Change Order

Change Order No.: 12 CBCL Project No. 241016.00
Date: November 29, 2025
To: Alex Sawyer – Harbour Construction
Contract Name: Mahone Bay Edgewater Street Improvements
Contract No.: 241016.00
Refer To: CCO-08 & Harbour Quotation Document
Copies To: Dylan Heide (Town of Mahone Bay)

Contract Name:	Mahone Bay Edgewater Street Improvements	Contract No.:	241016.00
CCO No.:	08	Date:	October 16, 2025
To:	Alex Sawyer (Harbour Construction)		
Copies To:	Dylan Heide (Town of Mahone Bay)

Park Area Distribution:

Date OCT 16/2025	Scale AS NOTED	Designed MF	Drawn MF/DS	Checked LO'K/AB	Approved JAB	CBCL No. 241016.00	Contract -
		EDGEWATER STREET IMPROVEMENTS					Drawing ESK04
		PARK AREA DISTRIBUTION

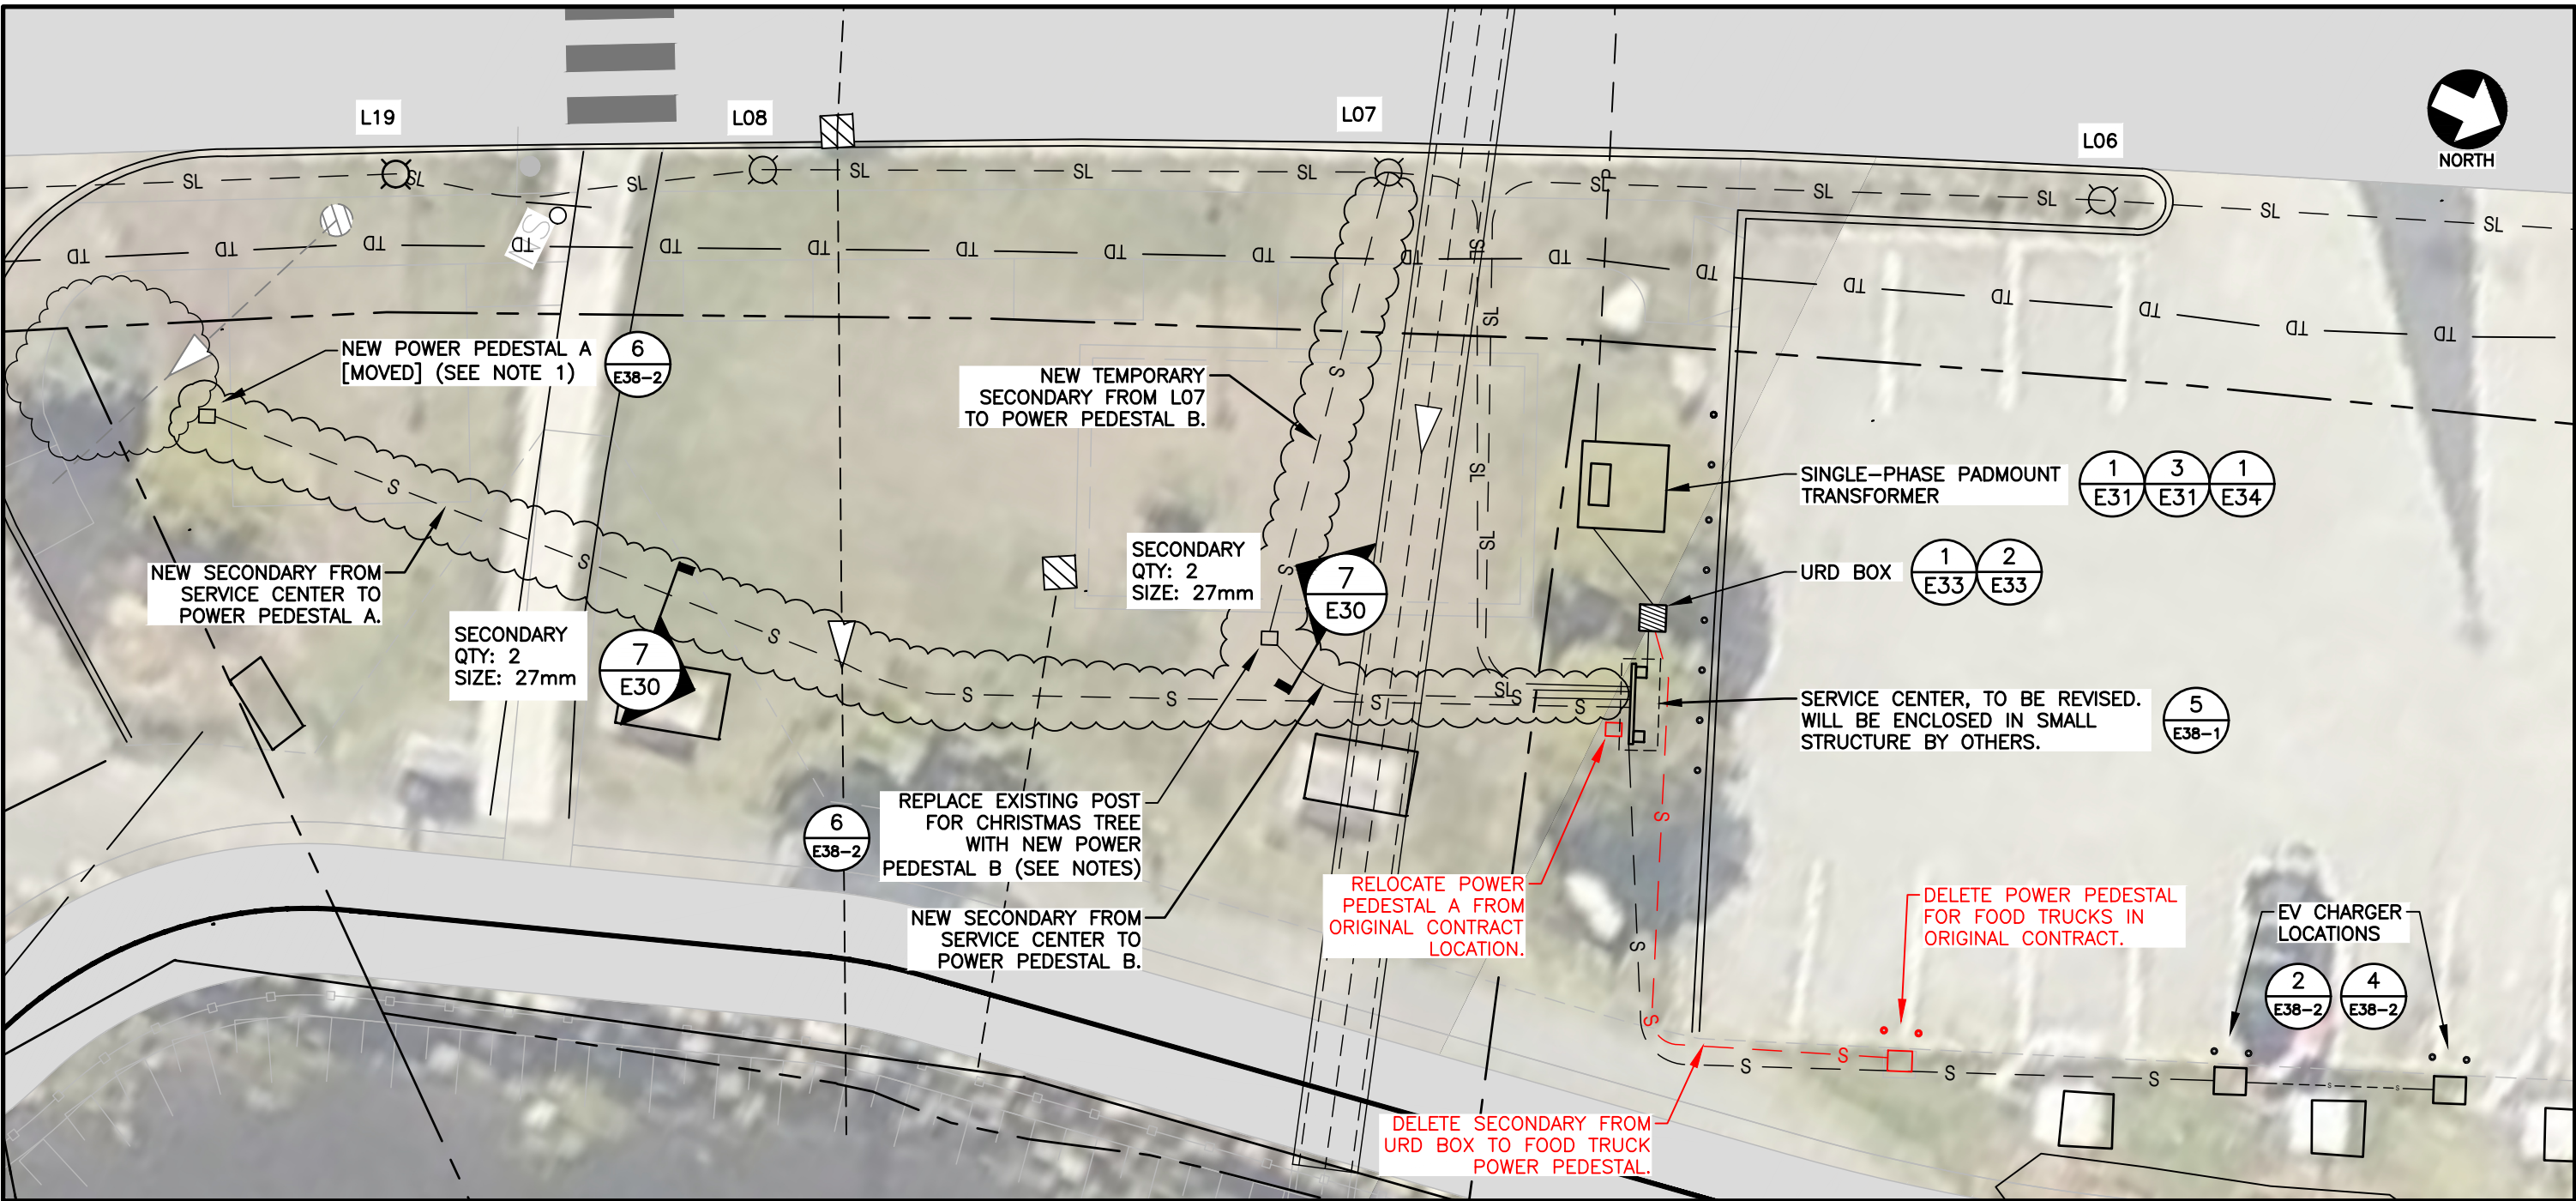
Please provide a lump sum price to complete the following revisions to the Park Area Distribution, refer to Sketch ESK04 and reissued drawings E38-1 and E38-2 attached. Changes from the original scope are as follows:

- Remove the power pedestal for food trucks; remove 15m of secondary to pedestal; remove two (2) bollards.
- Revise location of power pedestal for lighting (Power Pedestal A).
- Replace existing wood post with receptacles (used for Christmas tree power) with new power pedestal (Power Pedestal B).
 - Maintain connection to adjacent light pole (L07) on temporary basis to allow use of pedestal B until pad mount transformers are installed. To include approximately 11m of 27mm secondary.
- Add approximately 43m of 27mm secondary from new service center to new power pedestal A and B.
- Include secondary moles (junctions) in URD01.
- Revise service center per the details on E38-1:
 - Add one (1) meter and two (2) additional panels,
 - Add six (6) receptacles as shown,
 - Other revisions as shown.
 - Wood structure encapsulating service center to be completed by others.

- NOTES:**
- 1. INSTALL SERVICES FROM PANEL BOARD IN SERVICE CENTER TO POWER PEDESTALS. EXACT LOCATIONS OF NEW PEDESTALS TO BE COORDINATED IN FIELD WITH THE TOWN OF MAHONE BAY REPRESENTATIVES.
 - 2. MAINTAIN CONNECTION TO ADJACENT LIGHT POLE ON TEMPORARY BASIS TO ALLOW USE OF PEDESTAL UNTIL PADMOUNT TRANSFORMERS ARE INSTALLED.
